ADDITIONAL INFORMATION REQUIRED FOR

ANACONDA COPPER COMPANY'S

JACKPILE-PAGUATE

RECLAMATION PLAN

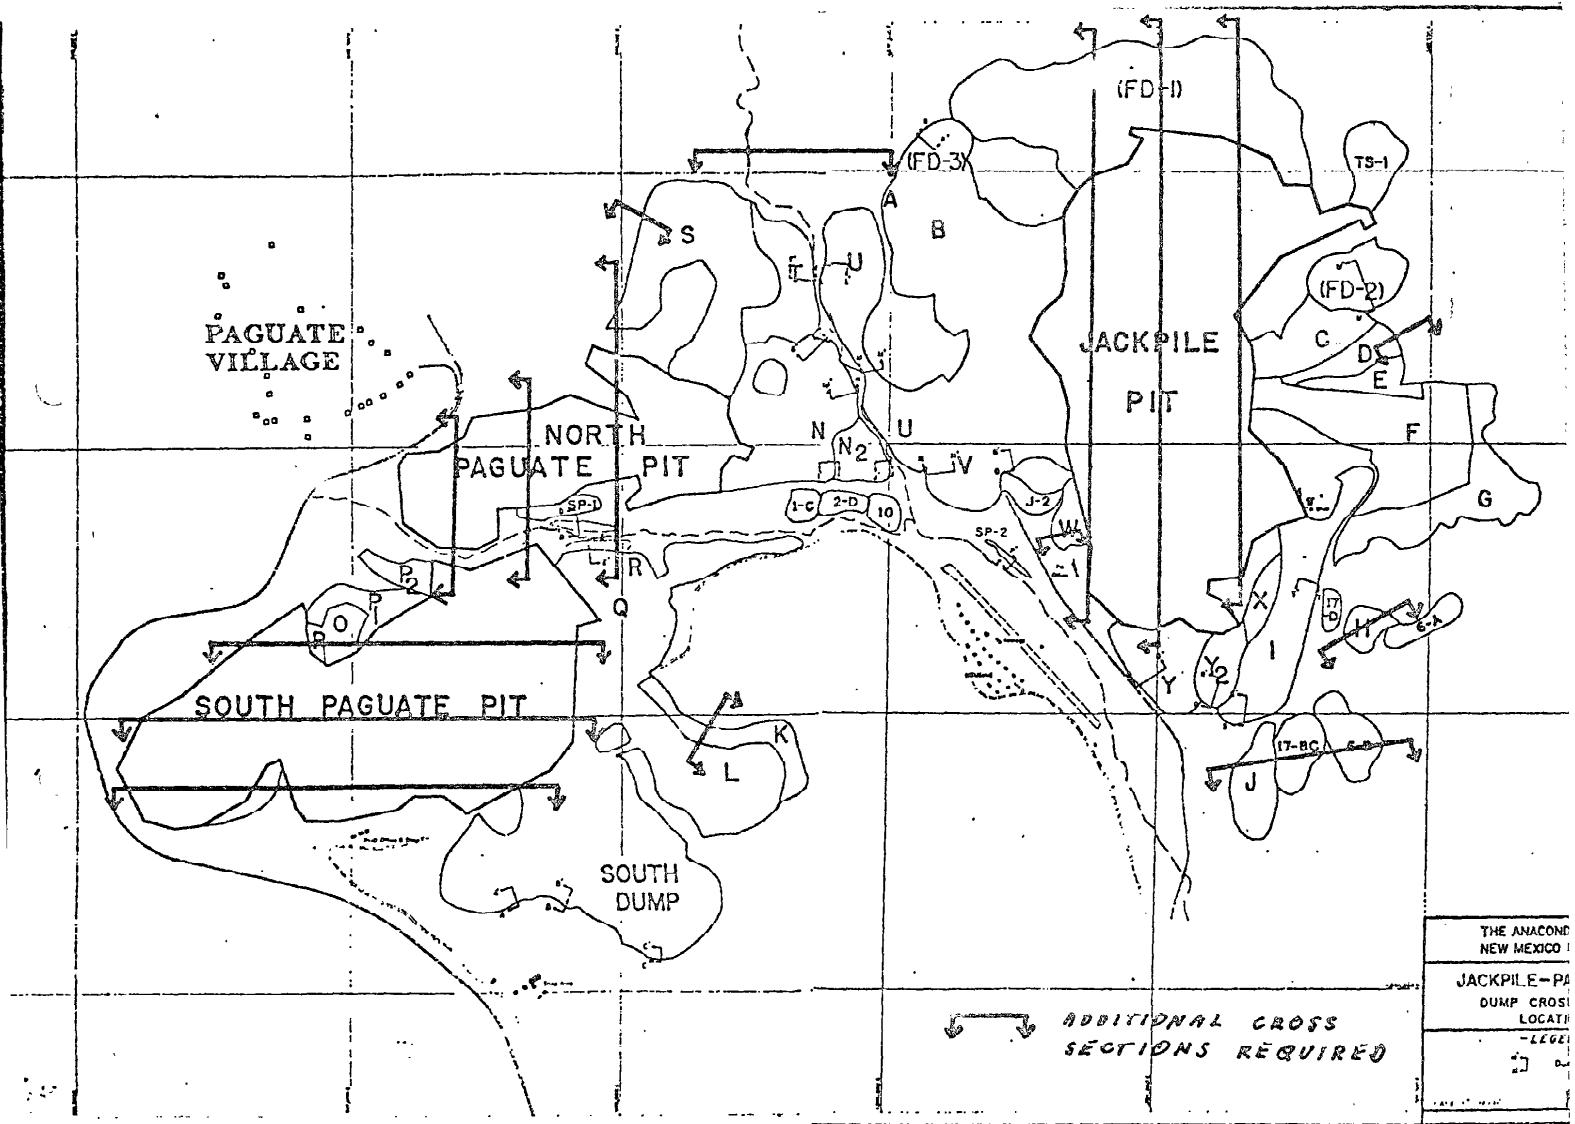
41. Page 33 states that "seed mixtures will vary with site conditions". Please define the seed mixtures and site conditions to be considered and the criteria used to determine the seed mixtures for a particular site.
